NORTHERN WOLVES
AIR CONDITIONING

Project: **Sunrise Rye Brook - Independent Living / Assisted Living**

Mechanical drawings dated: 07.15.2026 (GMP set)

Mechanical Value Engineering Proposals

M2002 AL basement - boiler room, pumps, heat exchangers, chimney enclosures

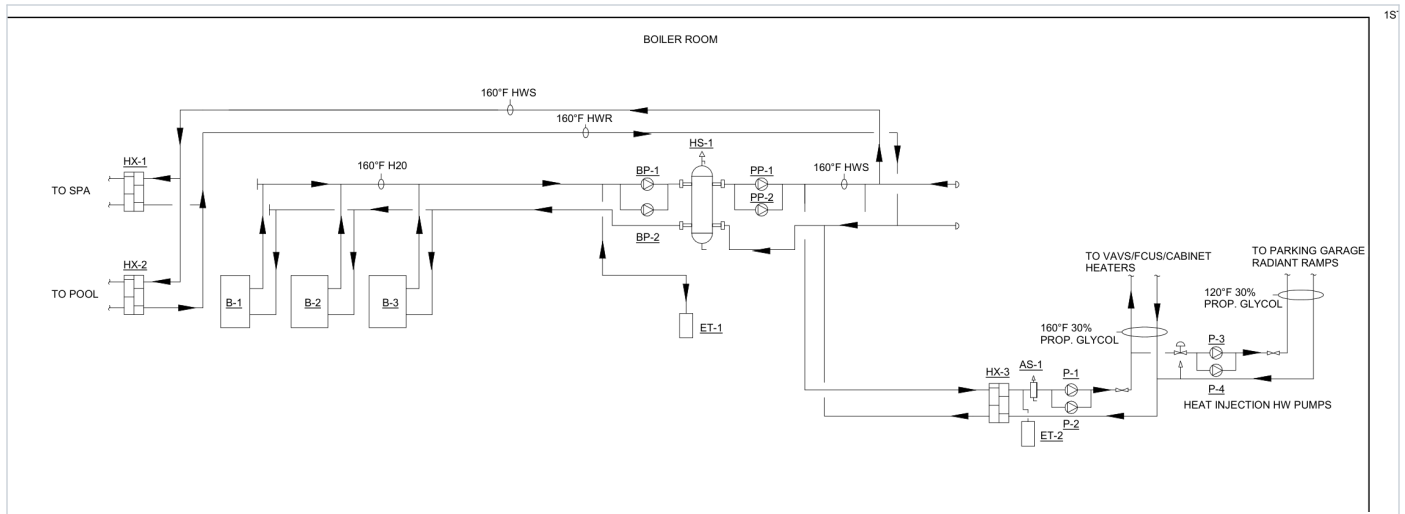
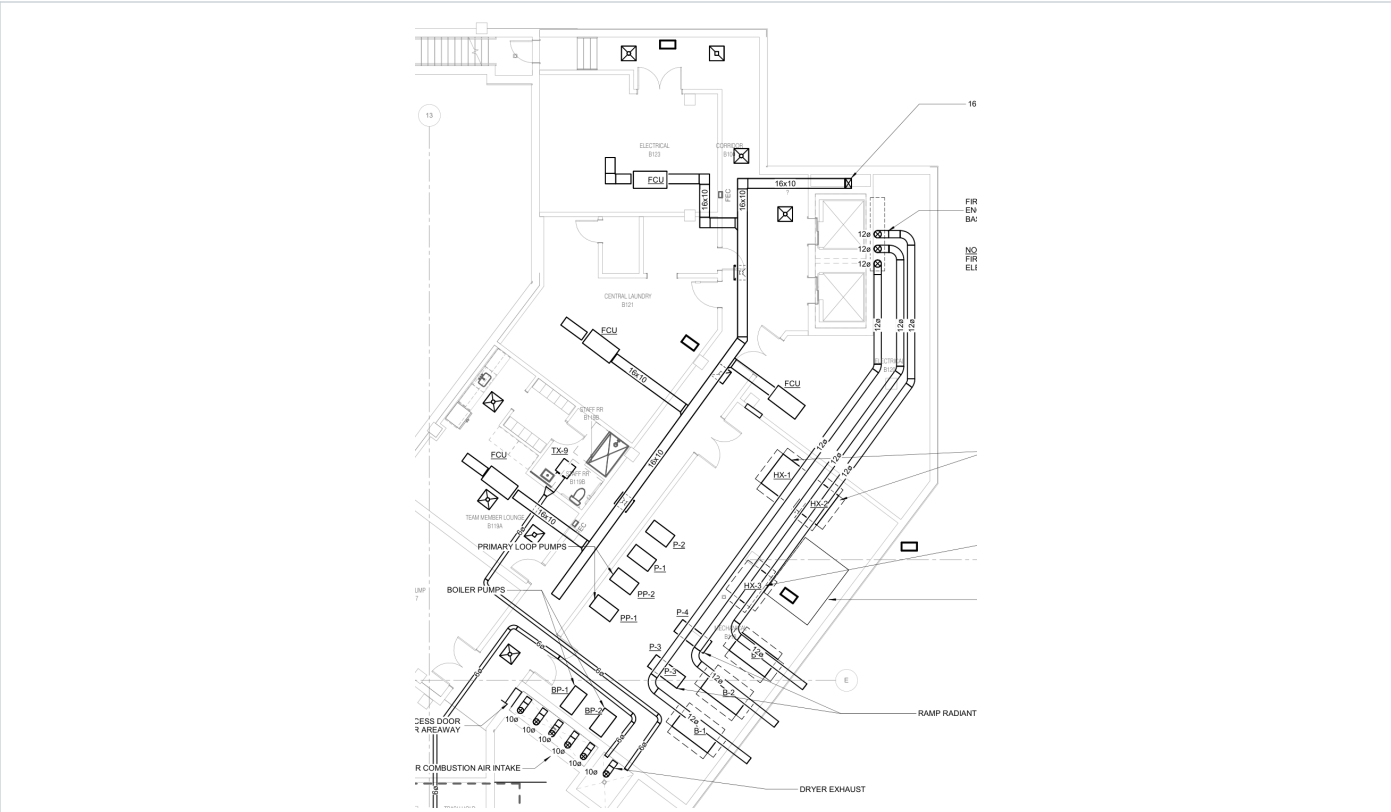
VE-01 Heating plant: delete boilers and hot water / glycol systems

- Three 1,999 MBH gas boilers B-1, B-2, B-3 (5,700 MBH output), primary / secondary with HS-1
- Pumps BP-1/2, PP-1/2, P-1 to P-4, expansion tanks ET-1/2, air separator AS-1, heat exchanger HX-3 to 30% glycol
- Fire-rated chimney enclosures basement to roof, combustion air areaway, water treatment, hot water and glycol distribution to the 1st floor and basement
- Connected heating load about 2,430 MBH: the plant is about 2.3 times the load

- Delete the boiler plant and all hot water / glycol distribution; the building runs on gas rooftop units, heat pump DOAS and the electric terminal heat in VE-02 to VE-06
- No boiler room equipment, chimneys, combustion air, water treatment, flushing or hydronic balancing
- Pool and spa heating by the pool contractor (by others)

M2015 1st floor piping IL area B - hot water to VAV boxes and cabinet heaters

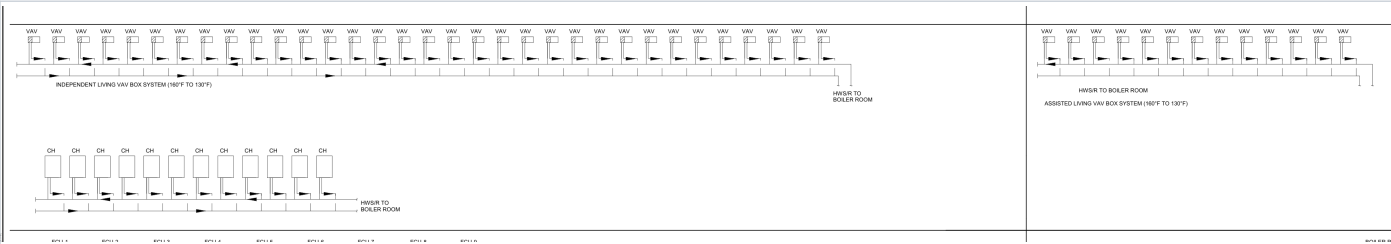
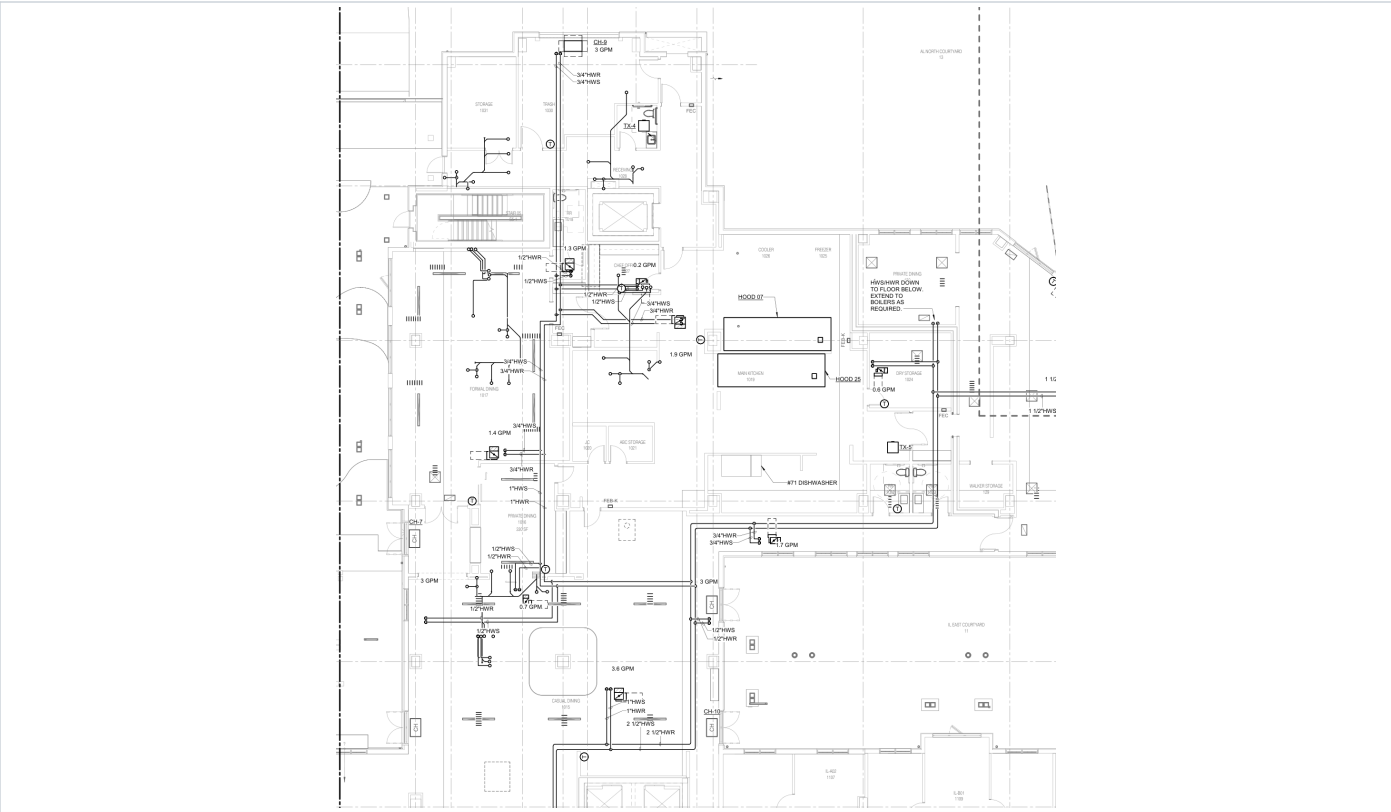
VE-02 VAV reheat: hot water coils to electric reheat

- 47 VAV boxes with hot water reheat coils (629 MBH, 45 GPM) on 5 rooftop units
- Hot water piping, control valves, balancing and insulation to every box (M2014 to M2016)

- Factory electric reheat coils with SCR control on the same VAV boxes; no piping, no control valves
- IMEG to confirm which interior zones need reheat at all (rooftop units already supply gas-heated air); cooling-only boxes where reheat is not required

M2011 1st floor ductwork - VAV boxes and cabinet heaters in dining / kitchen area

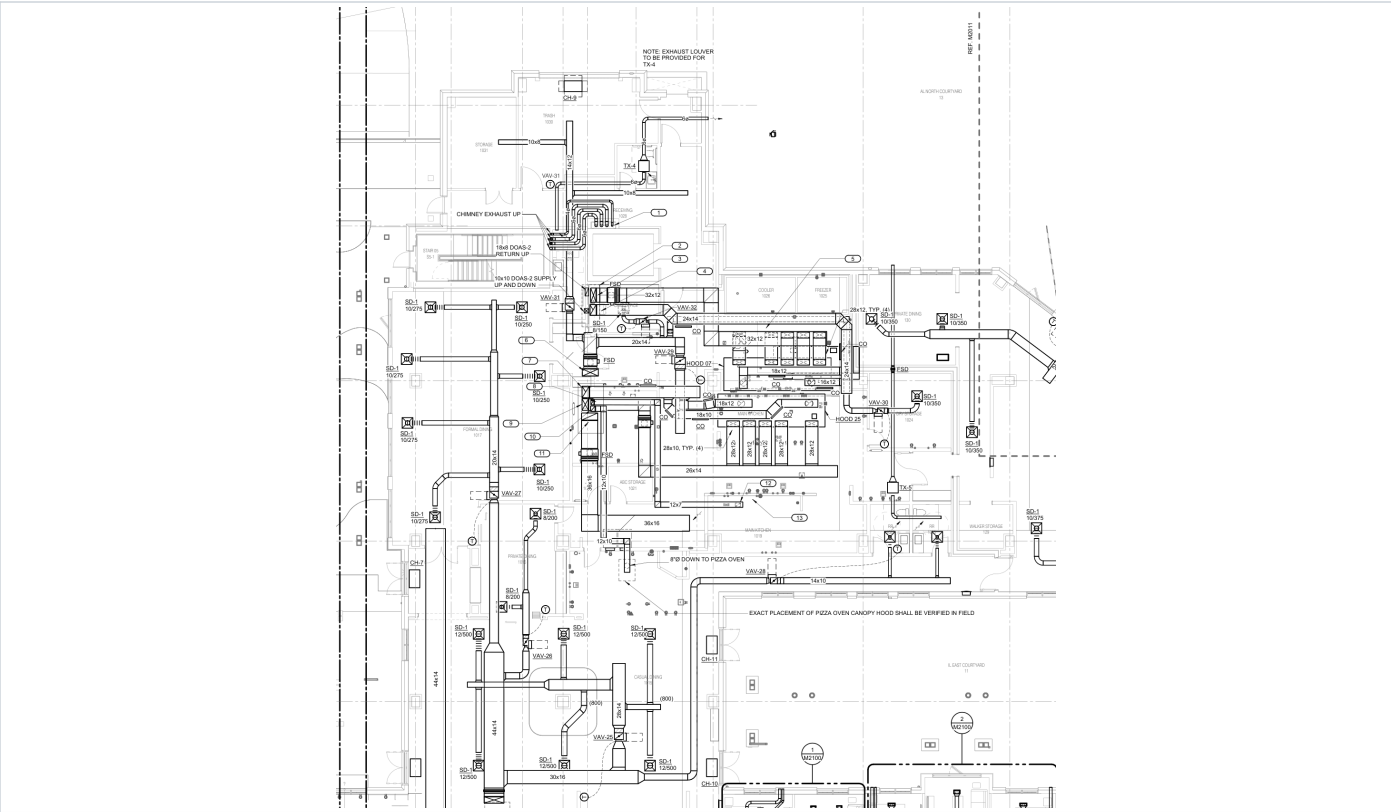
VE-03 Common areas: single-zone rooftop units in lieu of VAV zoning (alternate to VE-02)

- 5 large VAV rooftop units (7,000 to 11,000 CFM) serving 47 VAV zones with reheat

- Large open spaces on single-zone constant-volume gas / DX rooftop units, one per space type
- Offices and small rooms on ductless heat pumps; delete the VAV boxes and reheat
- Same approach as other recent Sunrise communities (e.g. Sunrise of Northport: small single-zone rooftop units plus heat pump terminals, no VAV, no boilers)

M2011 1st floor - CH-7, CH-9, CH-10, CH-11 locations

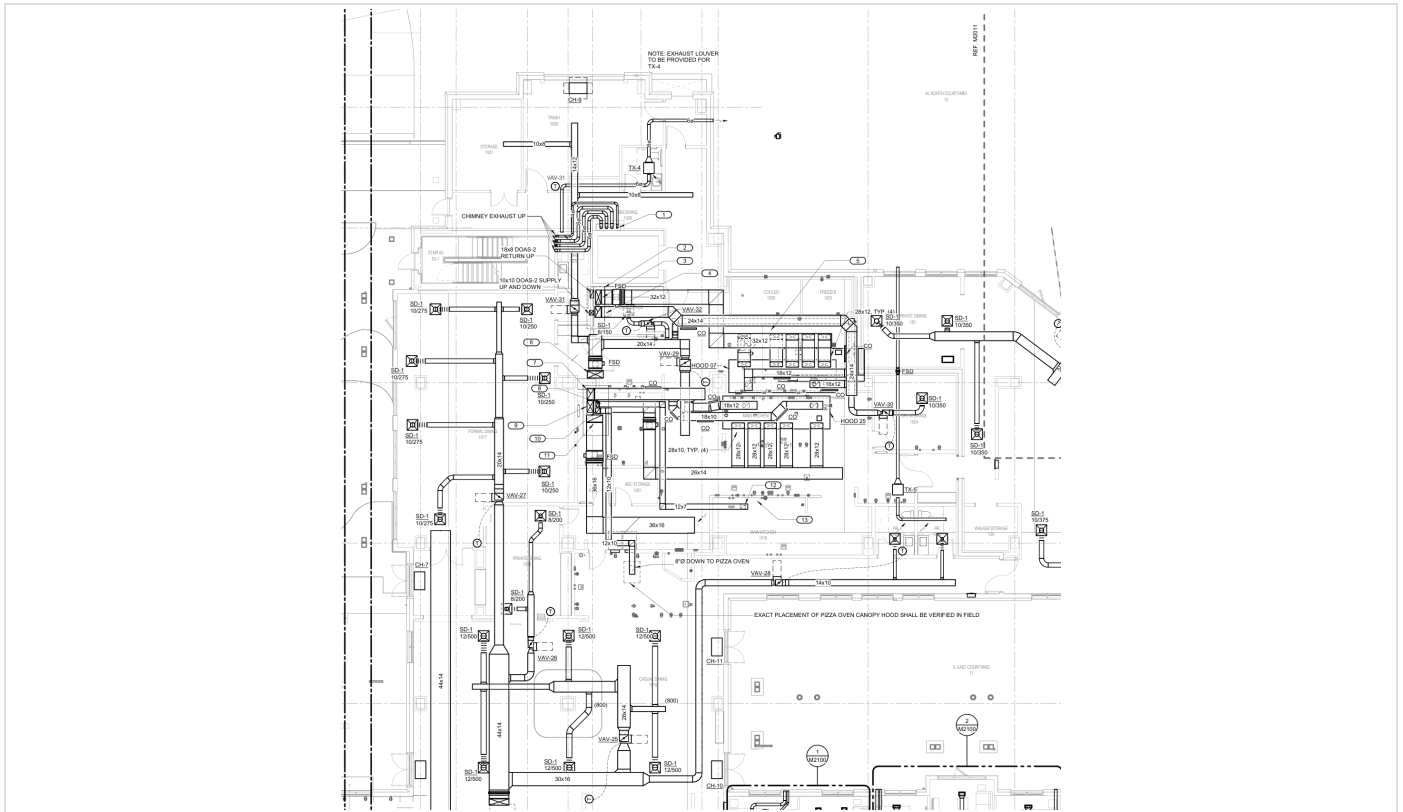
VE-04 Cabinet heaters: hot water to electric

- 12 hot water cabinet heaters (234 MBH) with piping and BMS control

- Electric cabinet heaters with integral thermostats, no piping, no BMS points

M2002 AL basement - FCUs in kitchen storage, residents' storage, corridor

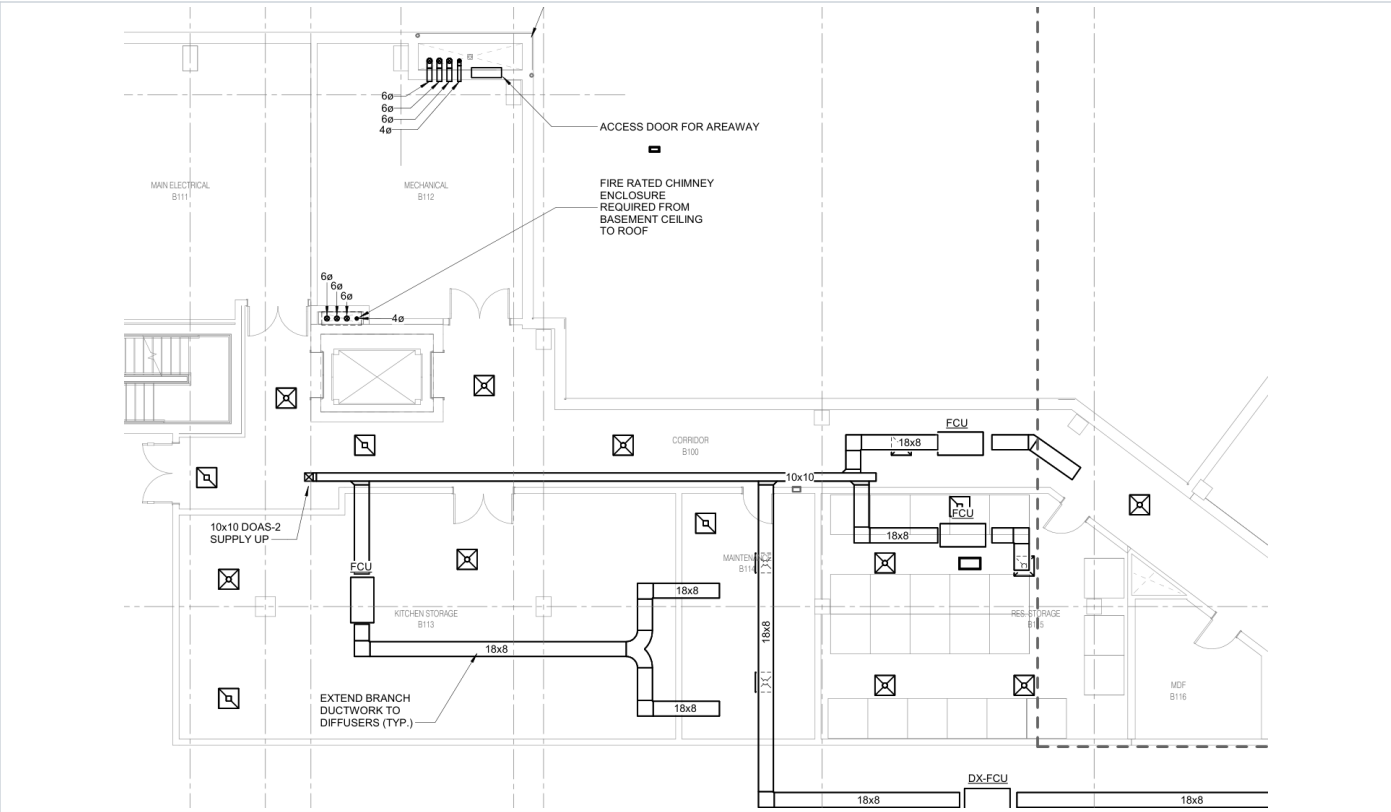
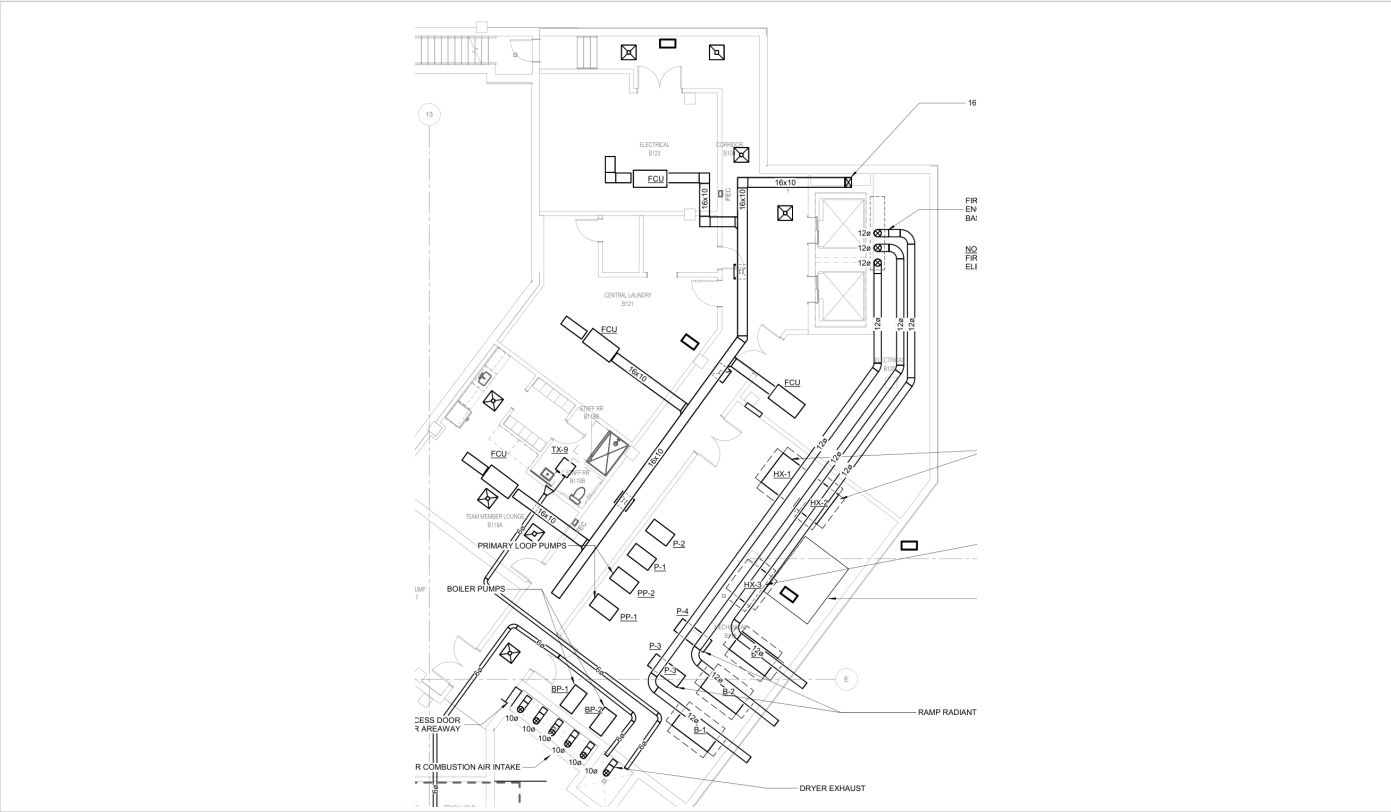
VE-05 Basement back-of-house fan coil units

- FCU-A, quantity 20, "basement heating", hot water / glycol heating coil only (schedule data blank); M5000 shows FCU-1 to FCU-17 on the glycol loop with RAD-1/2
- Each FCU takes a small DOAS branch at its inlet and recirculates the room (booster fan plus reheat)
- No glycol or hot water piping to these units is drawn on M2001 / M2003

- Delete the 20 FCUs and RAD-1/2; extend the DOAS branch ducts directly to the room diffusers
- Electric unit / wall heaters with integral thermostats only where there is freeze risk (trash rooms, rooms at areaways, louvers or exterior walls)
- Occupied rooms (staff lounge, corridor) on a small ductless heat pump or duct heater
- Electrical rooms, MDF and laundry need cooling and ventilation, not heat: ductless AC for MDF and electrical rooms, thermostatic exhaust / make-up for laundry (not on the drawings today)

M5000 Hydronic flow diagram - basement FCUs, RAD-1/2 and ramp snow melt loops

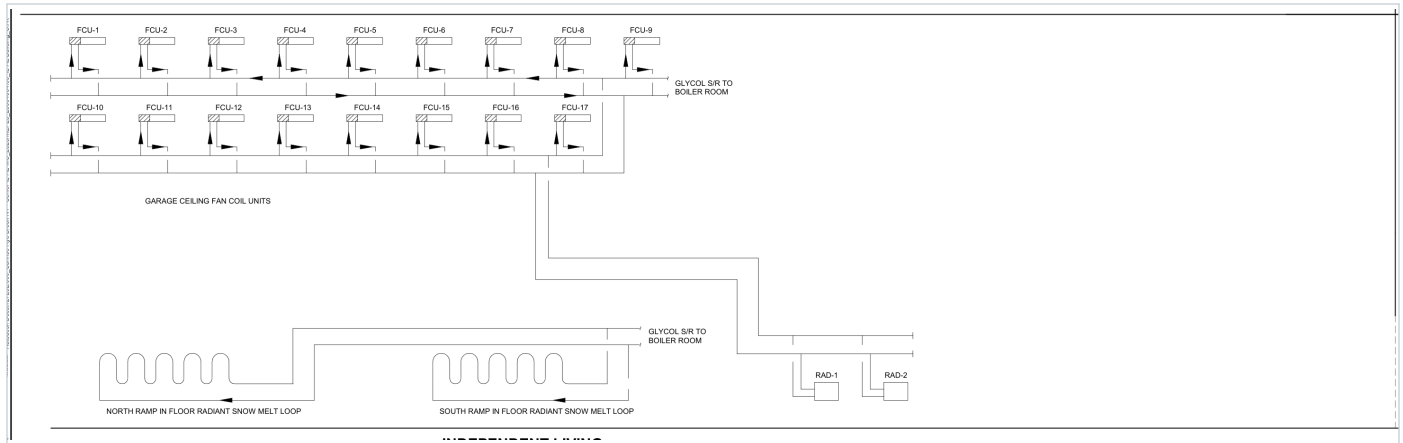
VE-06 Garage ramp snow melt

- In-floor radiant snow melt loops on both ramps from the boiler plant through HX-3

- Option A: no snow melt; trench drains and salting (owner decision)
- Option B: electric snow melt cable by EC, storm-only operation with load shedding
